[Docket No. FAA-2009-1088; Directorate Identifier 2008-SW-76-AD; Amendment 39-17872; AD 2014-12-11]

Airworthiness Directives; Sikorsky Aircraft Corporation Helicopters

ACTION: Final rule.

2014–12–11 Sikorsky Aircraft Corporation:
Amendment 39–17872; Docket No. FAA–2009–1088; Directorate Identifier 2008–SW–76–AD.

Figure 1 to Paragraph (e)(3)(iii)

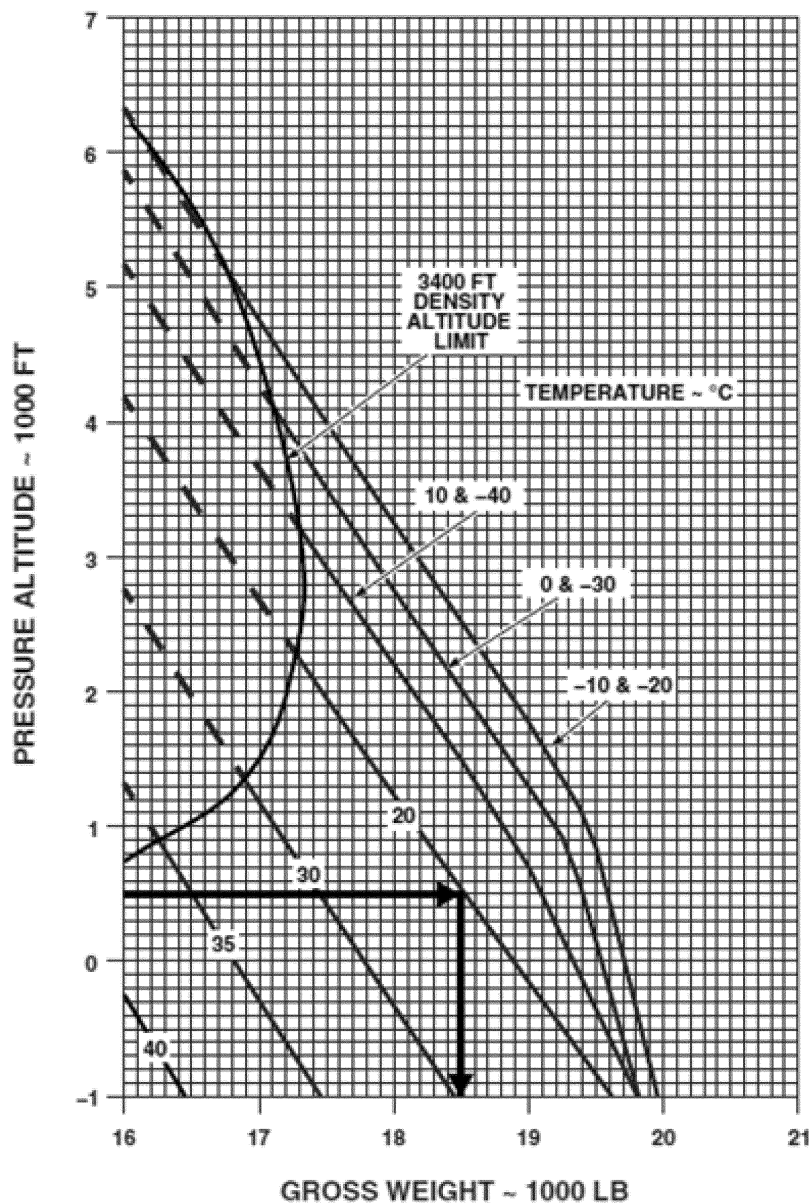
(iii) Add the following and insert Figure 1 to Paragraph (e)(3)(iii) of this AD: “HOIST” Maximum gross weight for Human External Cargo, which requires category ‘A’ performance capabilities, is limited to the gross weight determined in accordance with the following Figure 1 to Paragraph (e)(3)(iii) of this AD for your altitude and temperature with the air-conditioner, anti-ice, and bleed air turned off.

Note 1 to paragraph (e)(3)(iii) of this AD: Figure 1 to Paragraph (e)(3)(iii) of this AD becomes Figure 1–2A when inserted in the “Weight Limits” section of your RFM.

NOTE 1: THIS CHART DEPICTS THE GROSS WEIGHT, PRESSURE ALTITUDE, TEMPERATURE COMBINATION WHERE OEI HOGE CAPABILITY EXISTS USING 30 SECOND OEI POWER WITH A 60 SHP MARGIN.

NOTE 2: 15 FT OF GROUND CLEARANCE IS ASSURED IN THE EVENT OF AN ENGINE FAILURE AT 20 TO 80 FT AGL.
